UNITED STATES DEPARTMENT OF COMMERCE
Patent and Trademark Office
Address: COMMISSIONER OF PATENTS AND TRADEMARKS
Washington, D.C. 20231

APPLICATION NO.	FILING DATE	FIRST NAMED INVENTOR	ATTORNEY DOCKET NO.
09/315,403	05/20/99	HWANG	P 46000-0001
003490		TM02/1004	EXAMINER
DOUGLAS T. JOHNSON MILLER & MARTIN <i>Sent</i> 1000 VOLUNTEER BUILDING 832 GEORGIA AVENUE CHATTANOOGA TN 37402-2289.		EITSCHETTI, T.	ART UNIT PAPER NUMBER
		2167	DATE MAILED: 10/04/01

Office Action Summary	Application No.	Applicant(s)
	09/315,403	HWANG ET AL.
	Examiner Joseph A. Fischetti	Art Unit 2167

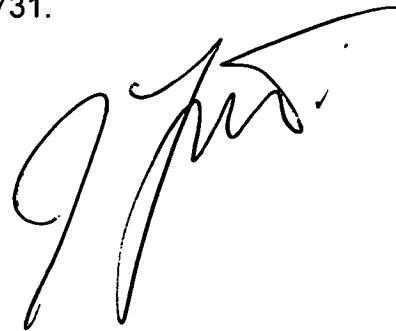
However, John et al. teaches a downwardly projecting central support which has a pocket which receives a correspondingly sized and shaped support of a tray which is stacked above it, in addition, John et al teach the use of pockets for the legs 24 which are sized and shaped to receive like legs of a tray disposed above it. John et al. does teach openings between linear support members 50,50.

It would be obvious to modify the tray in Haskins to include the centrally depending support 44 and openings which correspond the position of the legs of a try stacked above it since this would be desirable in the stacking of trays.
